6C Containment Debris Protection for ECCS Strainers

STD DEP 6C-1 (Figure 6C-1, ~~6C-2, 6C-3, 6C-4, 6C-5~~)

STD DEP Vendor

Figure 6C-1 Cassette Strainer Cutaway

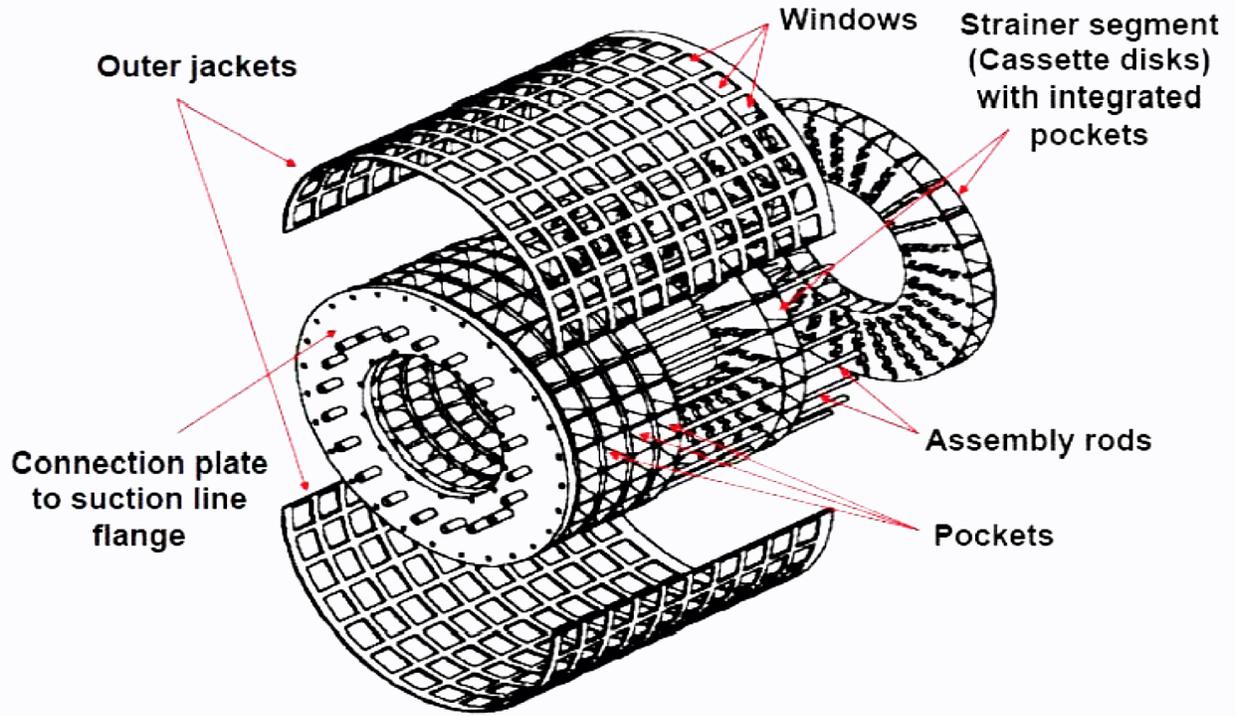
The information in this appendix of the reference ABWR DCD is subject to several changes due to the adoption of a complex ECCS strainer design (e.g. Cassette Type Strainer). Consequently, for clarity it is presented in its entirety with the following departures incorporated. This strainer design has been used at numerous BWRs in Japan and numerous PWRs in the United States. The strainer is described in this appendix. Departure STD DEP Vendor changes General Electric (GE) to Toshiba in Section 6C.1.
